Horniman CUE & Butterfly House Decarbonisation Design Tender

Clarifications

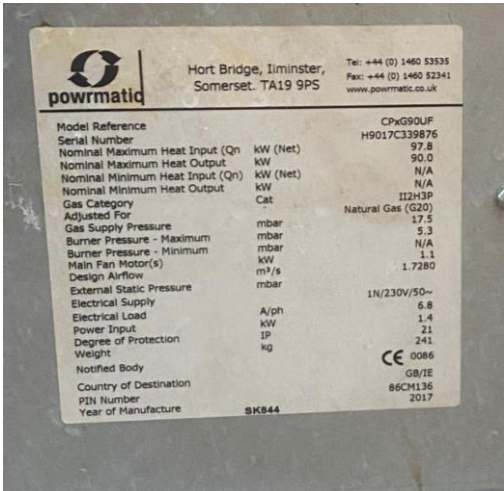
05/06/2025	What is to remain of the system?	To be determined as part of design stage.
05/06/2025	What is the make and model of the current heating system in the Butterfly House?	See photo on Page 2.
05/06/2025	Where is the substation for the BH and CUE?	To be investigated.
06/06/2025	We note the Standard T&C's are for Goods and Services; is it possible to provide a more suitable professional services agreement.	Our T's and C's can be used for professional services as well as contractors. Once appointed then we would be willing to consider alternative forms of contract.
06/06/2025	We do not undertake the PD role under the BSA. Will this preclude us from the bid?	We will require a costed proposal on how this will be managed as part of tender submission.
09/06/2025	Could I ask whether you operate a framework or approved contractors list for any smaller refurbishment / maintenance works, as we have a specialist works division which operates in this sector.	No we do not operate a framework.
